PRELIMINARY SHORT SUBDIVISION

STAFF REPORT & DECISION SUB23-003

Project No: SUB23-003

Description: A request to subdivide a 21,916 square foot lot into two new lots. Lot 1 would be approximately 11,329 square feet and Lot 2 would be approximately 10,588 square feet. The existing single-family residence on proposed Lot 1 would be demolished. Access to both lots would be from 78th Avenue SE via a shared access and utility easement.

BUILDING PAD PLAN

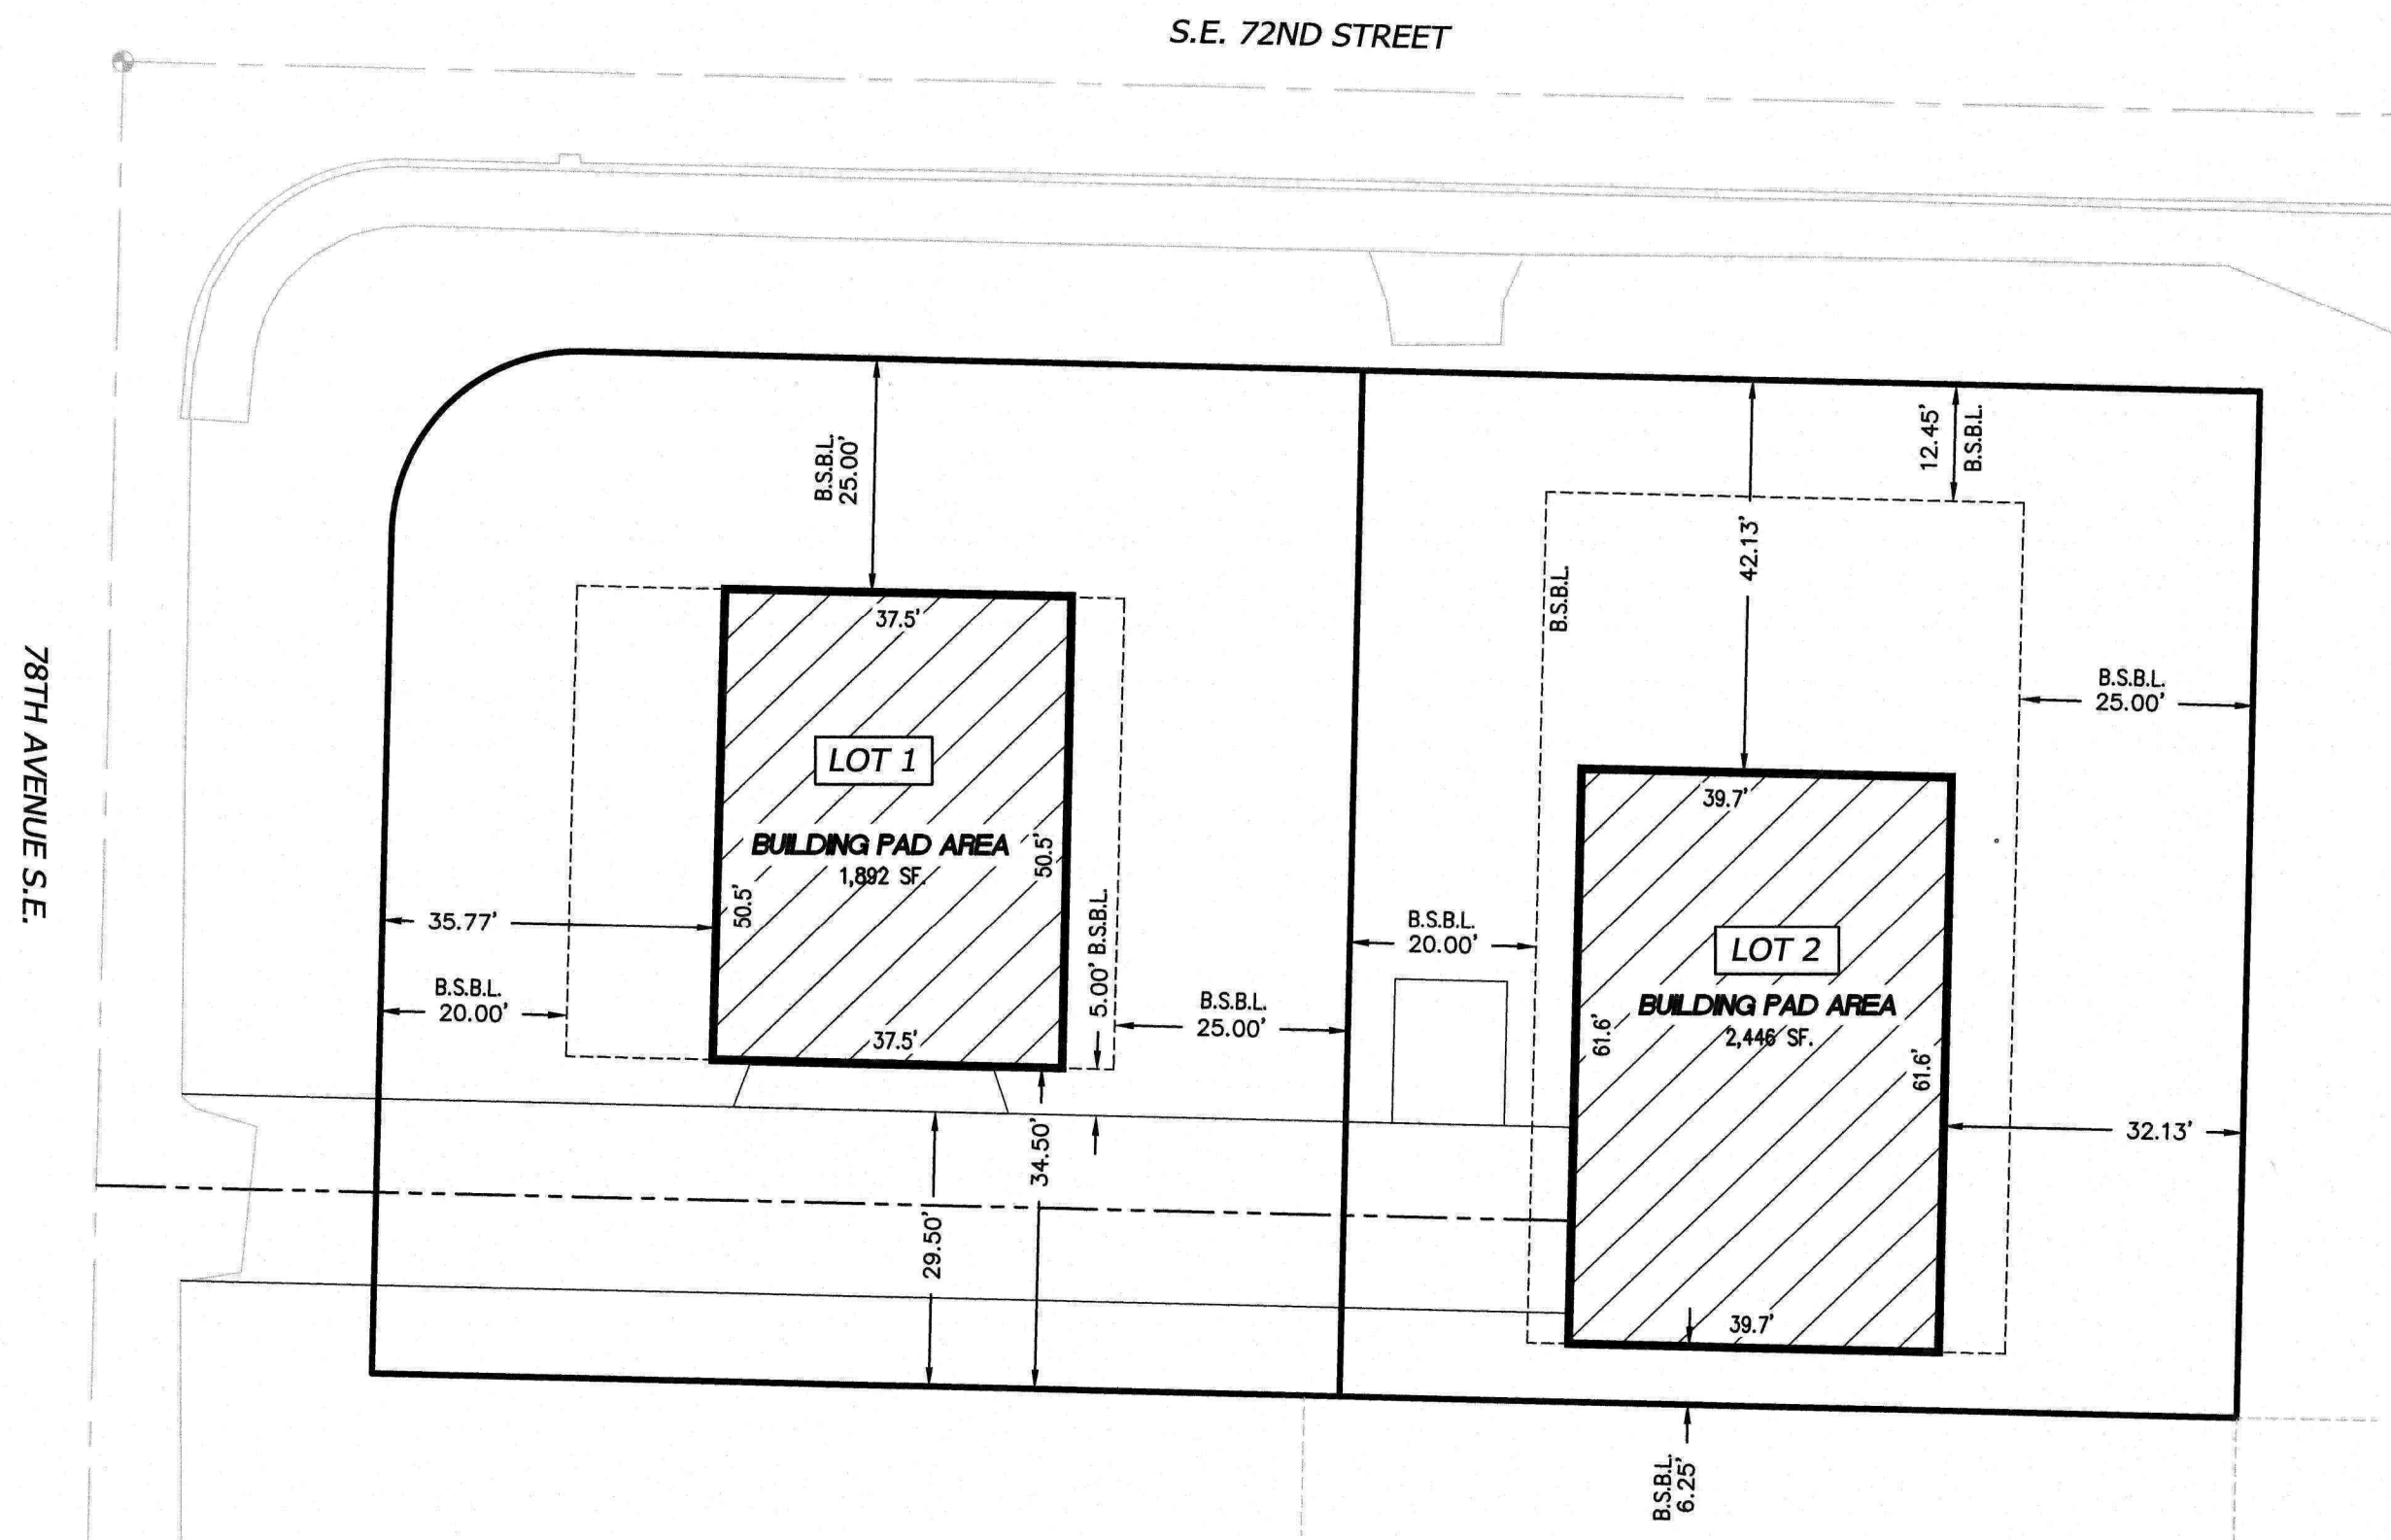
- a. Additionally, MICC 19.09.090(A)(3) requires no cross section of the building pad is less than 20 feet wide. The Building Pad locations shown on Sheet 6 and 10 contain several cross sections that are less than 20 feet wide.

2. Repeat Comment from SUB1 Review Letter: The building pad location shown restricts future development to exactly within the shapes outlined in the area labeled "Building Pad" on the site plan. "Building Pad" is outlined in MICC 19.09.090. It is recommended that the building pad be adjusted to only include those areas in the above code section. a. Additionally, MICC 19.09.090(A)(3) requires no cross section of the building pad is less than 20 feet wide. The Building Pad locations shown on Sheet 6 and 10 contain several cross sections that are less than 20 feet wide.

TREE PLAN MAP

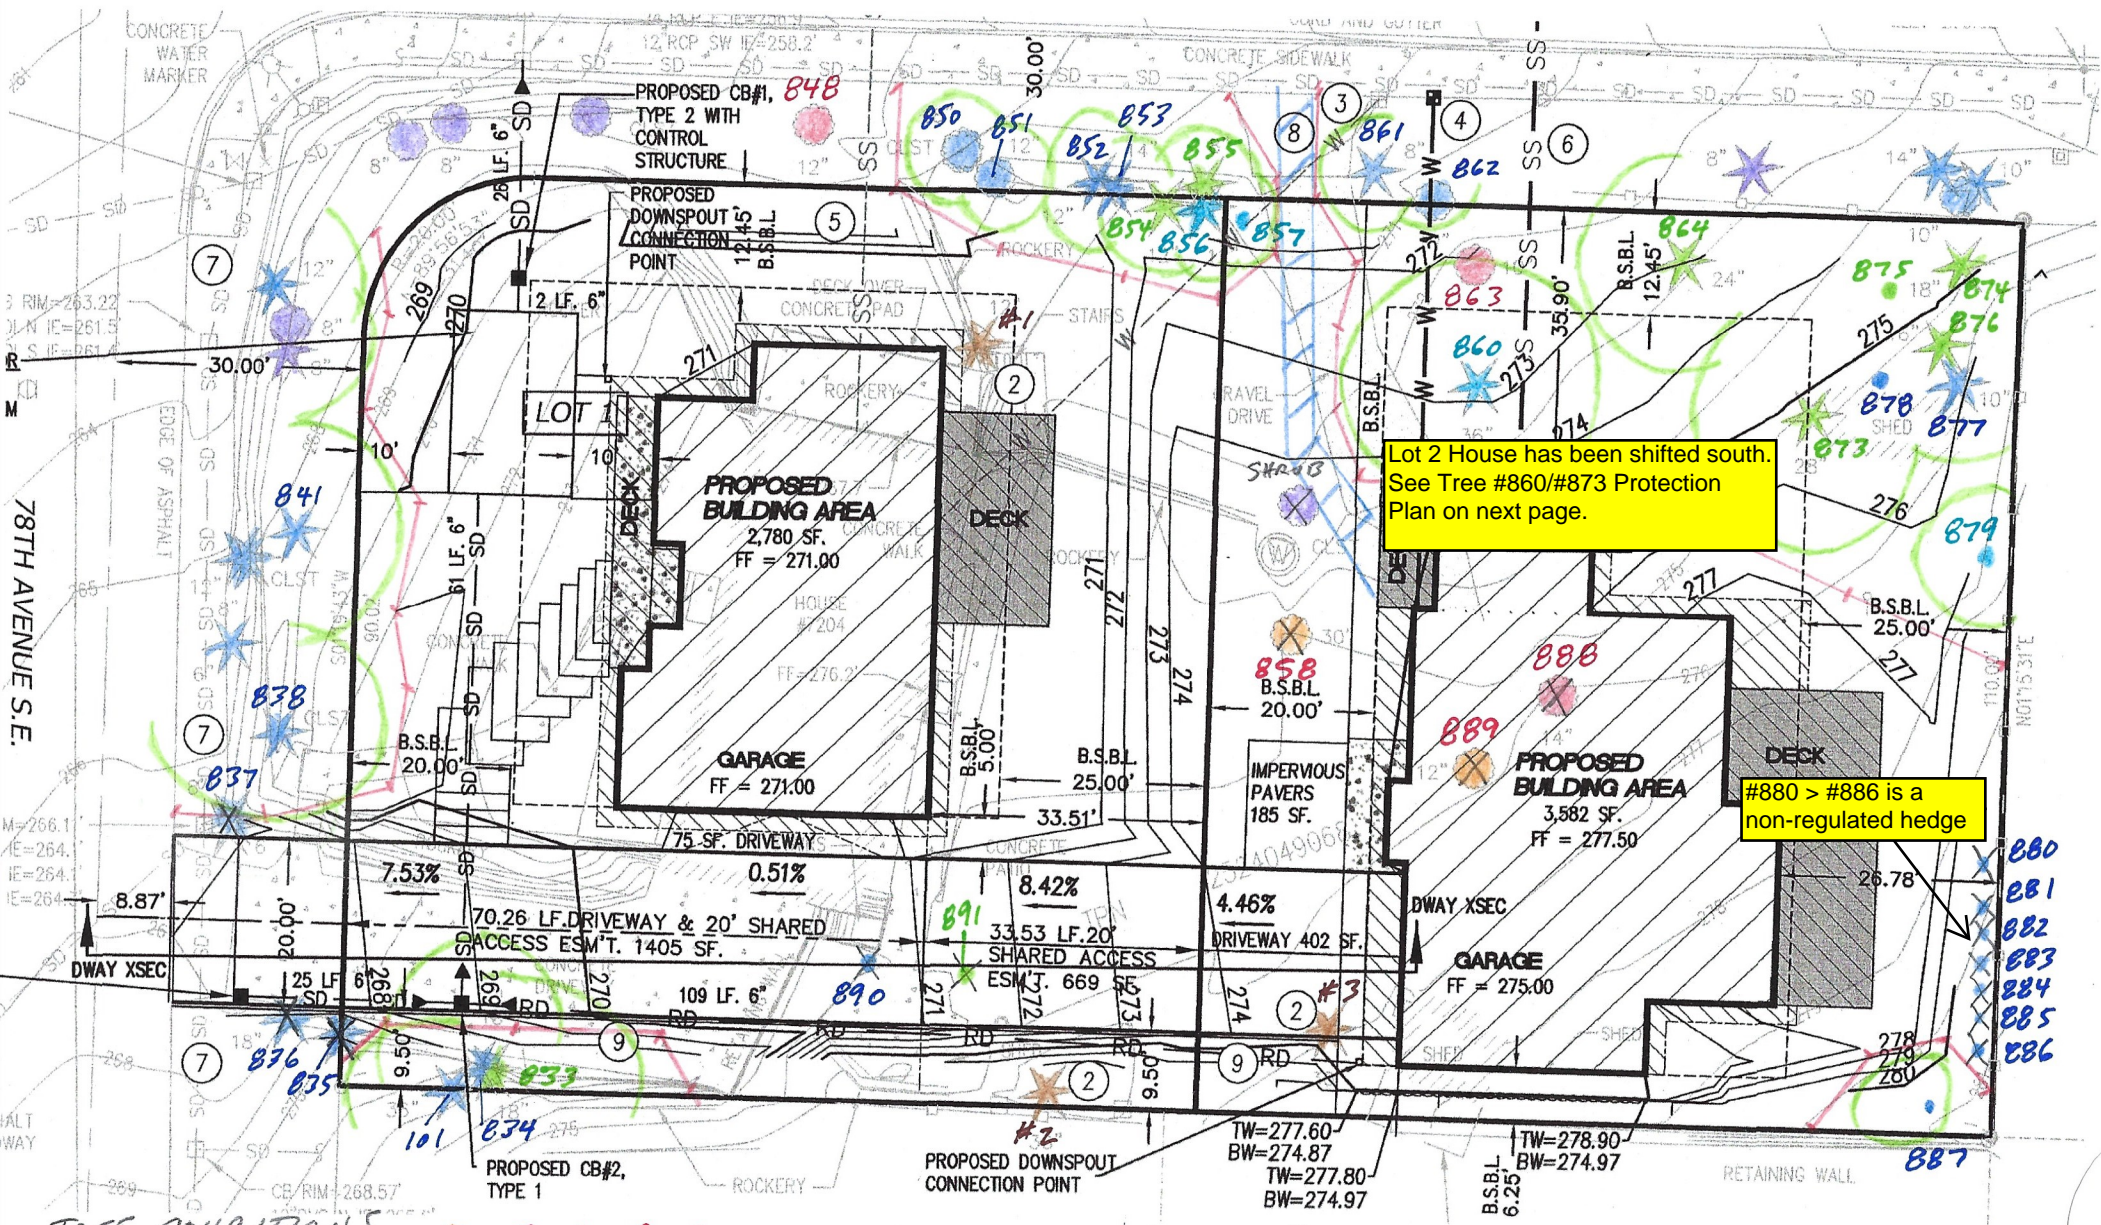
Lot 2 House has been shifted south. See Tree #860/#873 Protection Plan on next page.

#880 > #886 is a non-regulated hedge
